Re: Public Comment Letter for Santa Monica Groundwater Subbasin Draft GSP

Specific Comments on the Santa Monica Subbasin Draft Groundwater Sustainability Plan

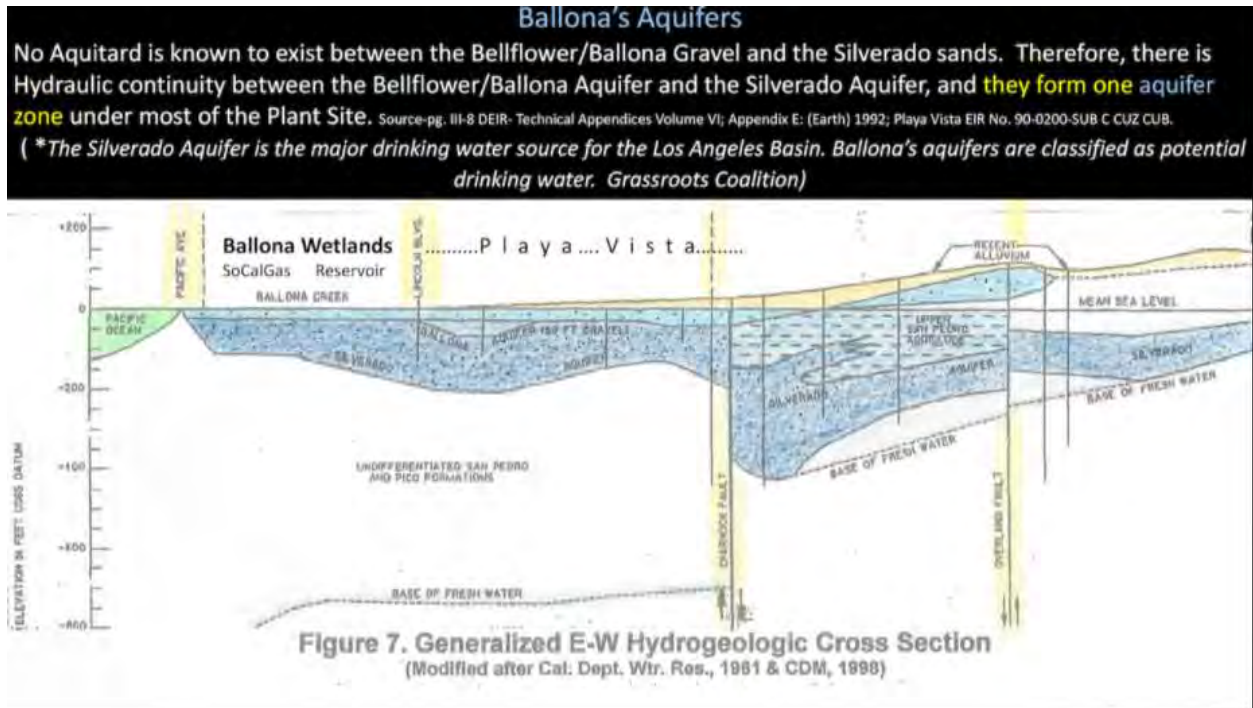
Grassroots Coalition believes that the Draft GSP of the Santa Monica Subbasin to be out of compliance with the investigative requirements of SGMA and believes that the Groundwater Dependent Ecosystem elements of SGMA have been excluded in whole and/or in part pertaining to the BALLONA WETLANDS and the sw region of the Subbasin. The BALLONA WETLANDS ECOLOGICAL RESERVE, as well as the underlying regional freshwater aquifers known individually as the Ballona, Bellflower and Silverado Aquifers, which act in this region as one unit, were not meaningfully addressed and the GSA excluded readily available data made known to the GSA and requested for inclusion. Despite our repeated requests for inclusion of critically important data, the GSA consultant company response at the August GSA 2021 Meeting was,

“I think you know we have done the groundwater dependent ecosystem work under SGMA to the requirements of SGMA”... Jill Weinberger, Dudek consulting company at 1:31:21 Meeting Video.

Per the Santa Monica Subbasin GSA Meeting of August 2021, comment above from the GSAs’ consultant company Dudek, and their Draft GSP response, Grassroots Coalition believes that the Draft should not be accepted by the Department of Water Resources due to numerous inaccurate conclusory statements and extensive data gaps pertaining to the southern region of the Subbasin and in particular, the Ballona Wetlands Ecological Reserve and all of Ballona’s public trust lands and water as a Groundwater Dependent Ecosystem (GDE).

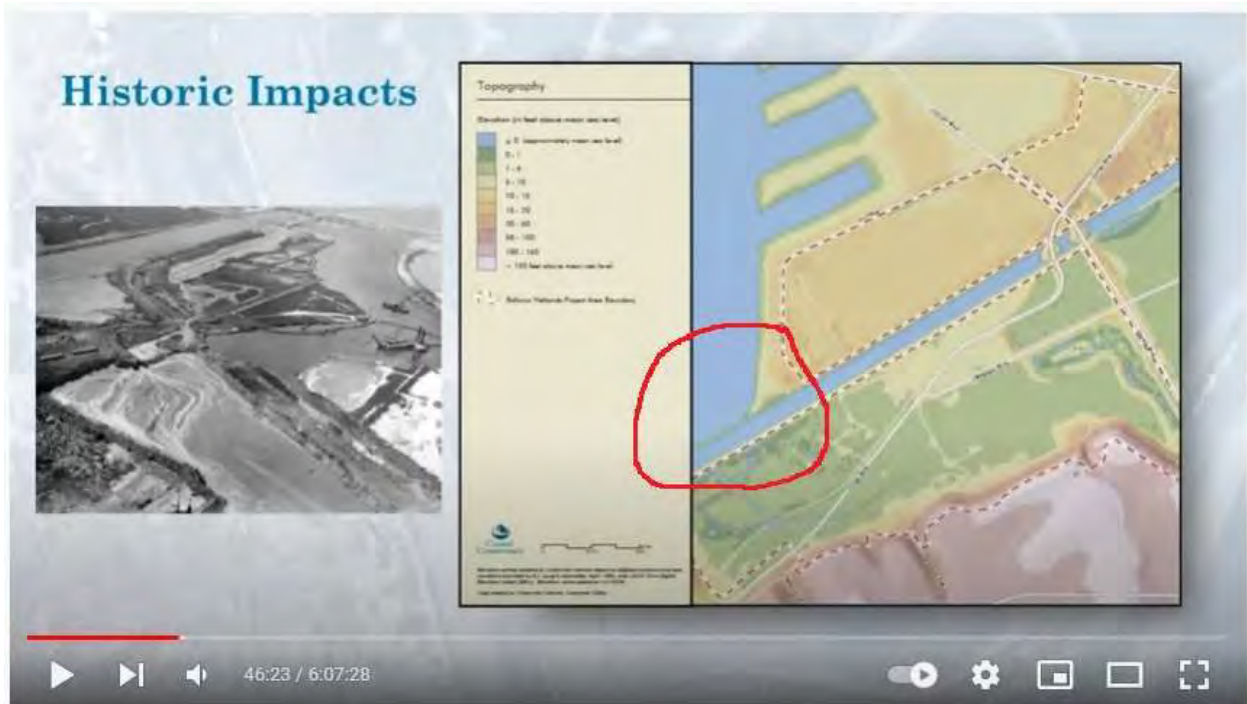
During the recent Coastal Conservancy Meeting noted above, both the Coastal Conservancy's lead Mary Small, who in the 2007-8 timeframe was also a Bay Foundation Board Member and contributed to the creation of the bay concept, and CDFW's Director Chuck Bonham repeatedly stated to Conservancy Board Members that the CDFW Plan for conversion of Ballona into a full tidal, saltwater bay—has no bearing on the continuing operations of the SoCalGas natural gas storage (operations). 2:54:57.

While true in the sense that CAL GEM and the CPUC do provide oversight of the SoCalGas operations, what is omitted is that neither Cal Gem nor the CPUC have been consulted per CDFW's Plan of saltwater intrusion. Director Bonham at 2:33:00 cites that CDFW wants the infrastructure out of the Reserve....that CDFW wants the infrastructure to be removed from the land to be restored... What is omitted in such overly broad and simplistic comments spoken ostensibly for neophytes to oil/gas operations, is that there is nothing in the FEIR discussing the hazards of corrosion and inability to access **the subsurface infrastructure that IS NOT REMOVED & WILL ALWAYS REMAIN** as potential conduits of gas and oilfield contamination. What is not addressed are the enhanced corrosion dangers to all the SoCalGas infrastructures including any new drilled wells. The saltwater interface with oilwells causing leakage due to corrosion is already well documented in SoCalGas wells of Playa del Rey operations. One only needs to look at the Ballona Channel to see outgassing that originates from abandoned wells. It is easy to view abandoned oilwells leaking Playa del Rey oilfield gases, which can and do leak gases, to the surface in Ballona Lagoon Marine Preserve. SoCalGas reservoir gases are documented as part of oil/gas well leakage to the surface. Cal Gem (aka Division of Oil & Gas) shut down SoCalGas/Playa del Rey for a year in 2010 due to reservoir gas leakage to the surface. The leakage was discovered due to litigation by Grassroots Coalition against SoCalGas which culminated in gas monitoring to be done as part of our Settlement Agreement. A URS gas study found the reservoir gas leakage. These are all real and potential dangers that state legislators, the City of Los Angeles are already trying to see fixed and as yet, have not been.
